Access Compliance Report

Public Rights-of-Way

(Curb Ramps)

Intersection ID: 51310	Main Street: I-485_RA	Cross Street: W_W_T_HARRIS_BV	Location: NE
ADA ID: D5FC74892DB0	Ramp Type: Perp	Initial Pass/Fail: Fail	Overall Compliance: No
Severity Score: 13.75			
Codes/Mitigation Info/Possible Solution		Field Measurements/Component Compliance

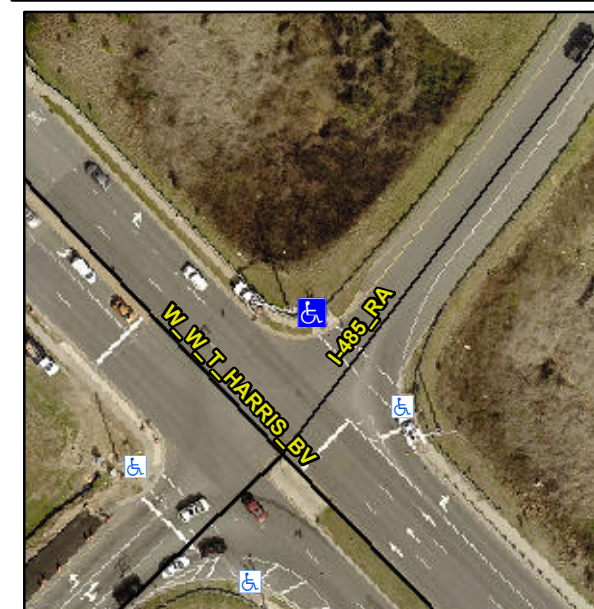
Compliance	Description	Data	Compliance	Description	Data
N/A	Ramp Length (in)	89.0	No	Ramp Slope (%)	8.5
Yes	Ramp Width (in)	48.0	Yes	Ramp XSlope (%)	2.9
N/A	Flare Type LT	N/A	N/A	Flare Type RT	N/A
N/A	Flare Slope LT (%)	N/A	N/A	Flare Slope RT (%)	N/A
N/A	Flare Traversable LT?	N/A	N/A	Flare Traversable RT?	N/A
N/A	Landing Length (in)	N/A	N/A	DWS Provided?	N/A
N/A	Landing Width (in)	N/A	N/A	DWS Contrast?	N/A
N/A	Landing Slope (%)	N/A	N/A	DWS Length (in)	N/A
N/A	Landing X Slope (%)	N/A	N/A	DWS Full Width?	N/A
N/A	Landing Curb? (Y/N)	N/A	N/A	DWS Offset (in)	N/A
N/A	Shared Landing?	N/A			
N/A	Gutter Ponding?	N/A	N/A	Gutter Slope (%)	N/A
N/A	Gutter Lip Ht (in)	N/A	N/A	Gutter X Slope (%)	N/A
N/A	Painted X Walk1?	Yes	N/A	Painted X Walk2?	N/A
	X Walk 1 Direction	To SE		X Walk 2 Direction	N/A
N/A	X Walk 1 Width (in)	113.0	N/A	X Walk 2 Width (in)	N/A
	X Walk 1 Slope (%)	0.4		X Walk 2 Slope (%)	N/A
	X Walk 1 X Slope (%)	3.6		X Walk 2 X Slope (%)	N/A

Remove & Replace Entire Ramp.
